Treatment and Disposal of Waterworks Sludge from Existing Water Treatment Works

Environmental Impact Assessment Final Assessment Report

October 1995

Final Assessment Report

Figure 9.3 : Water Treatment Processes and Proposed Works at Tai Po Road WTW

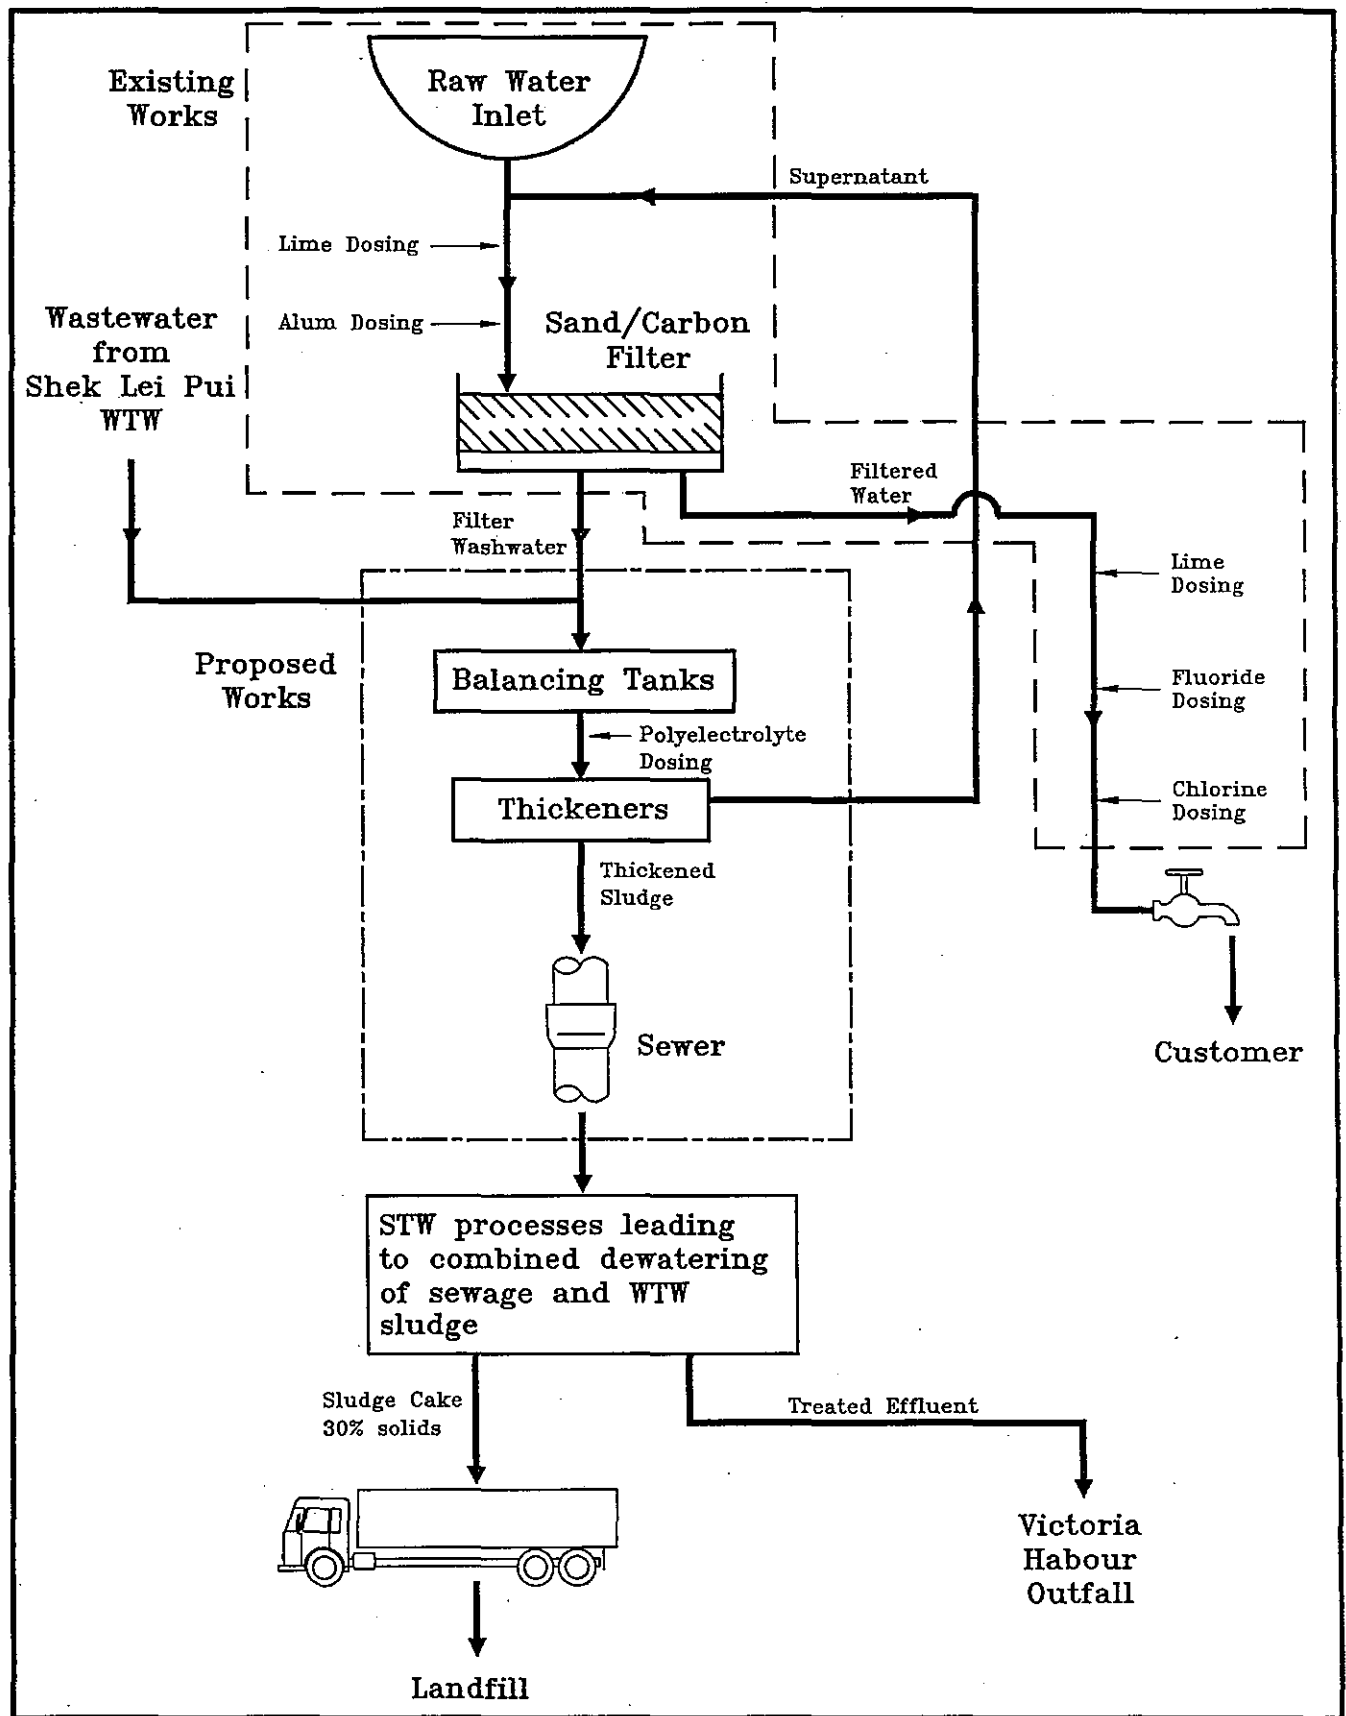
(f) The description "Wastewater from Tai Po Road WTW" on the left hand side of Figure 9.3 should read "Wastewater from Shek Lei Pui WTW".	Agreed.
	2. <u>Section 6 - Red Hill WTW</u> As pointed out in the last paragraph of Section 6.1.2 on P 38, the treatment works has two distinct sludge sources, viz from washwater recovery tanks and flocculation tanks. However, the proposed sludge treatment facilities as shown in Figures 6.2 and 6.3 have only catered for the sludge from washwater recovery tanks and not for those from flocculation tanks. The Consultant has to include both sludge sources in their proposal.	The volume of sludge from the flocculation tanks has been advised as being 1.2 m ³ every 5 days and as previously responded to in comments to the PSR the quantity of solids has been accounted for. The necessary hydraulic connections will be made. The connecting pipe from the flocculation tank has already been installed by WSD.

Figure 12.1
Proposed Development and Nearest Sensitive Receiver Location-Tai O WTW

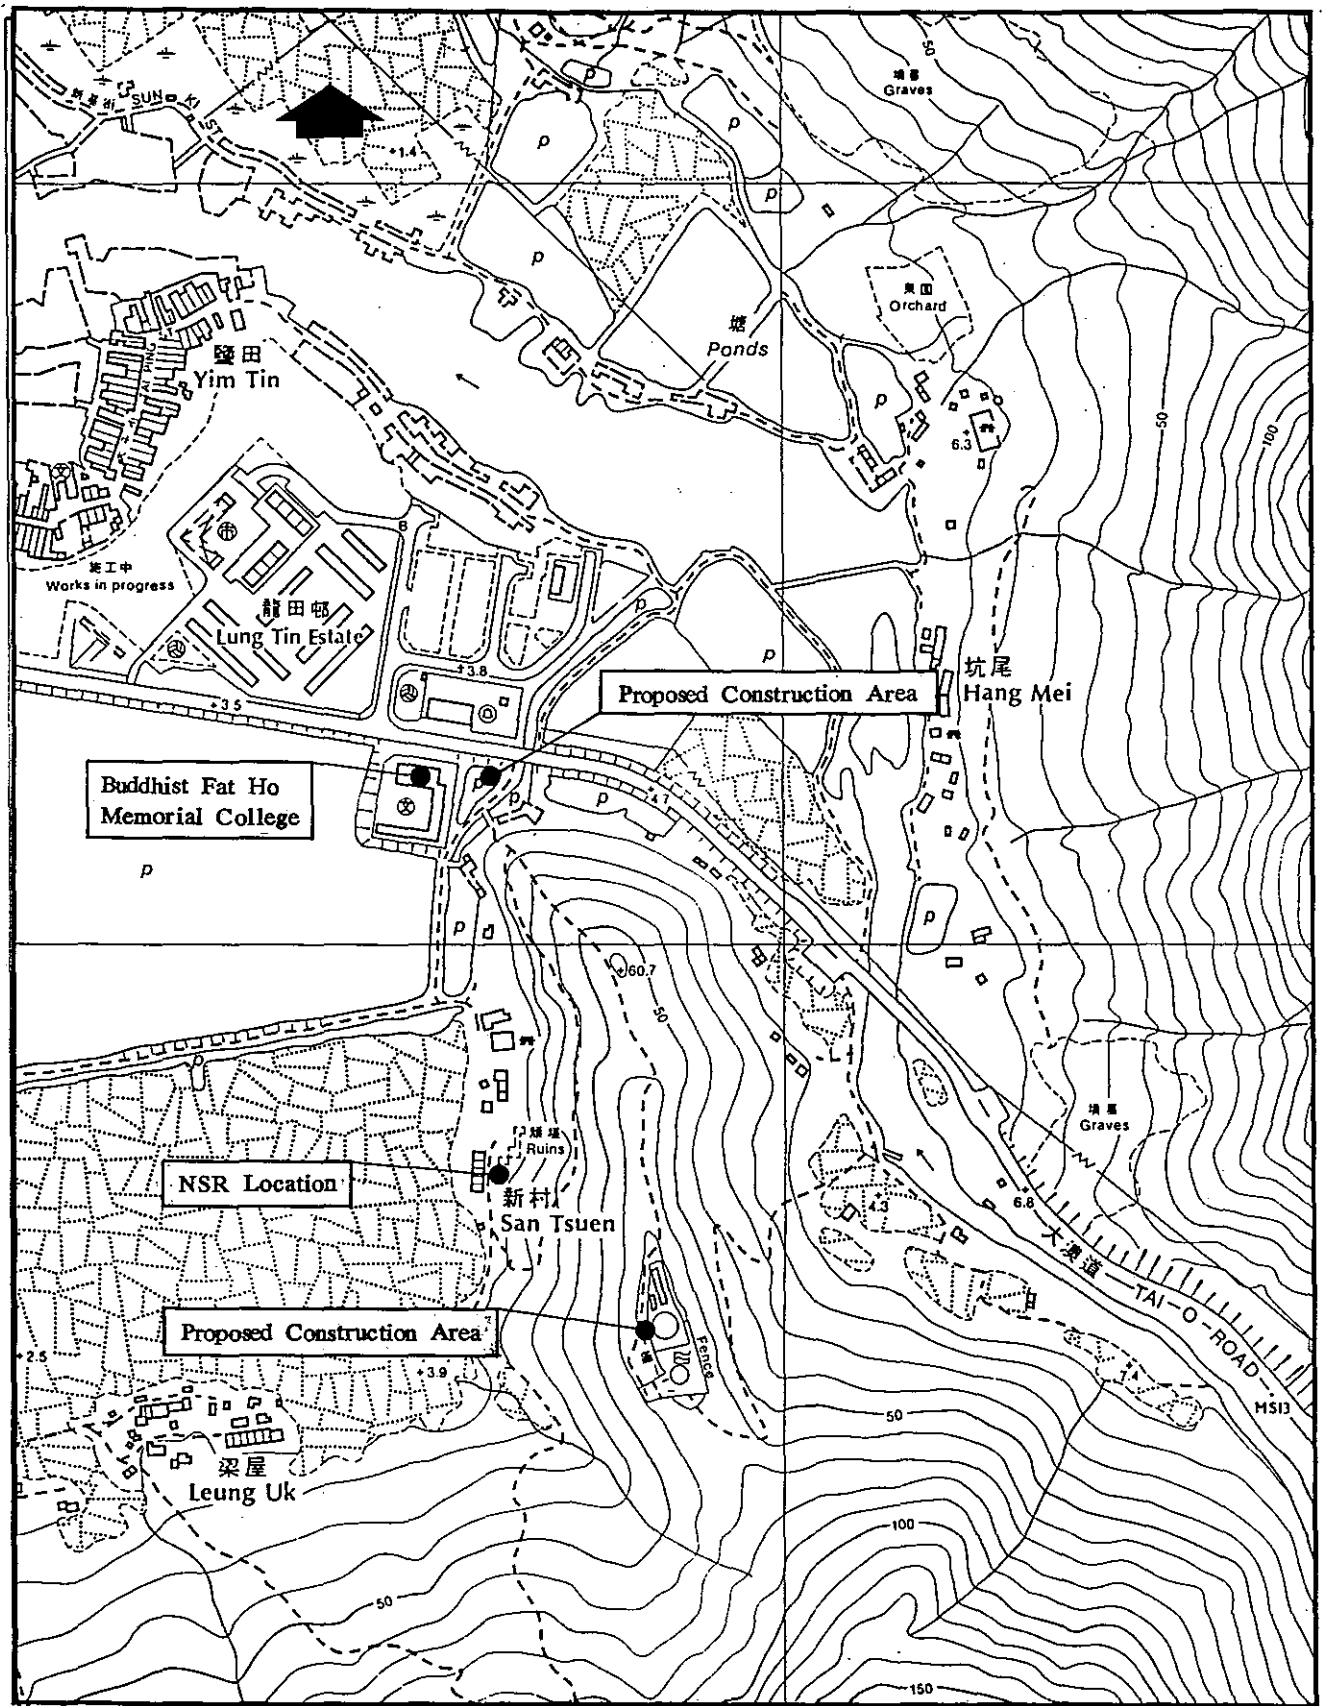
- Tai O
- (e) The proposed works include a pipeline linking the WTW and a sludge holding tank. As the pipeline has not been shown in Figure 12.1, I cannot offer any comment.

- The pipeline is shown in Figure 12.2 and Figure 12.3, and described in Section 12.2.2.
- I understand from Mr K H To of DEP that a copy of the draft Final Report has also been sent to CHE/HK. However, please include in the distribution list for future circulations CHE(D&M)/NT and CHE/HK in place of D of Hy.
